SUBJECT: NuScale Power, LLC Response to NRC Request for Additional Information No. 9440 (eRAI No. 9440) on the NuScale Topical Report, "Evaluation Methodology for Stability Analysis of the NuScale Power Module," TR-0516-49417, Revision 0

NuScale Response to NRC Request for Additional Information eRAI No. 9440

NRC Question No.: 15.09-1

NRC Question No.: 15.09-2

Figure 1. Effect of Pellet Conduction Time Constant.

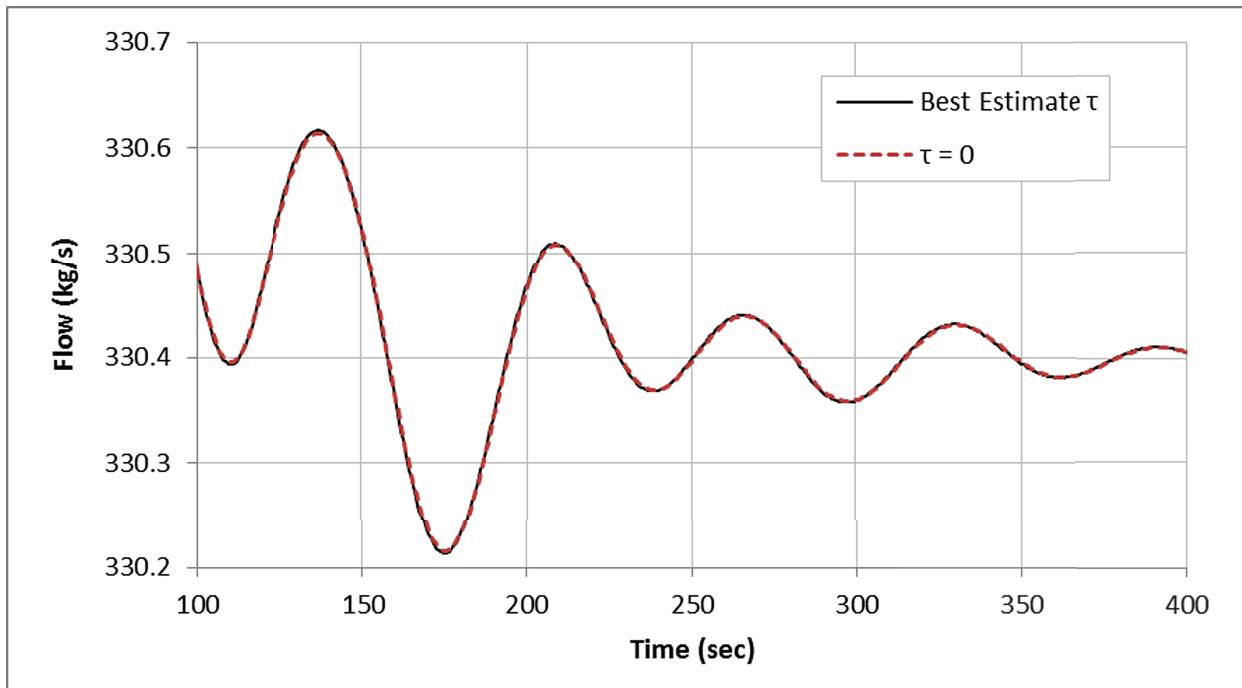
1. If the intent of the RAI 8808 response is to apply a quasi-steady heat conduction model in place of the conduction dynamics model currently described in section 5.6.4.1 of the NuScale Topical Report (TR) TR-0516-49417, "Evaluation Methodology for Stability Analysis of the NuScale Power Module" then:
 - Revise the stability TR accordingly, and
 - Justify the quasi-steady approximation using quantitative arguments
2. If the intent of the RAI response is to apply PIM's dynamic conduction model as currently discussed in section 5.6.4.1 of the stability TR then:
 - Provide the technical basis for the fuel thermal time constant correlation. It

- Confirm that the correlation is not fuel-design specific.
 - Clarify which terms in Equation 5-92 are exposure dependent.
 - Because density, heat capacity, conductivity, and diameter change with exposure, explain what values are used if the exposure dependence is ignored.
 - Confirm that the core average exposure is used to evaluate exposure dependent quantities.
-

It should be emphasized that the solution of the transient equation using a finite time constant that is much less than the oscillation period is nearly equivalent to the quasi-steady state solution. The transient model in PIM has been selected since it was not known *a priori* that the

oscillation period is much larger than the fuel rod thermal time constant. Therefore, the approximations used or implied in the time constant have insignificant effect on the NuScale module stability calculations. This is demonstrated by performing a PIM calculation at 20% of rated power and BOC using the best estimate pellet conduction time constant and a sensitivity case where the time constant is forced to be zero (quasi-steady-state). The two solutions are plotted together in Figure 1, and the difference is shown to be negligible.

In conclusion, the NuScale stability methodology and code apply a dynamic pin conduction model, however a quasi-steady state model can be imposed by input and produces similar and equally valid results due to the insensitivity of the NPM stability to the dynamic pin conduction phenomena.

Figure 1. Effect of Doppler Effective Fuel Temperature Weighting Factor.

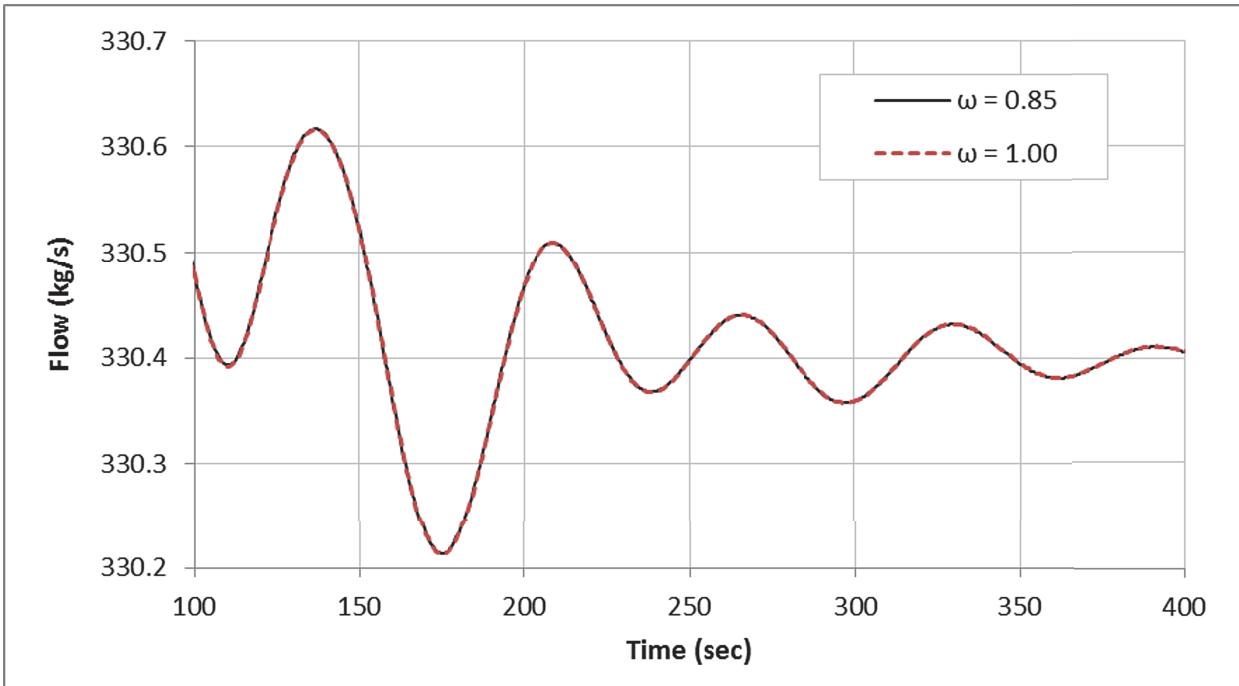
1. Provide the temperature weighting factor (ω) from Equation 5-102 of the stability TR.
2. Explain why the value of the temperature weighting factor is appropriate.
3. Explain why the burnup-dependent factor (a) from Equation 5-109 of the stability TR is appropriate for stability analysis, generically.

The estimates of the weighting factor from the cited literature are $\omega = 0.92, 0.6, 0.89, 0.8$ and 0.7 which indicates that the value used in PIM analysis of $\omega = 0.85$ is reasonable. No sensitivity was observed in PIM analysis due to the variation of the weighting factor within the recommended range. See Figure 1 which shows two cases with $\omega = 0.85$ and $\omega = 1.0$ where the results are very close.
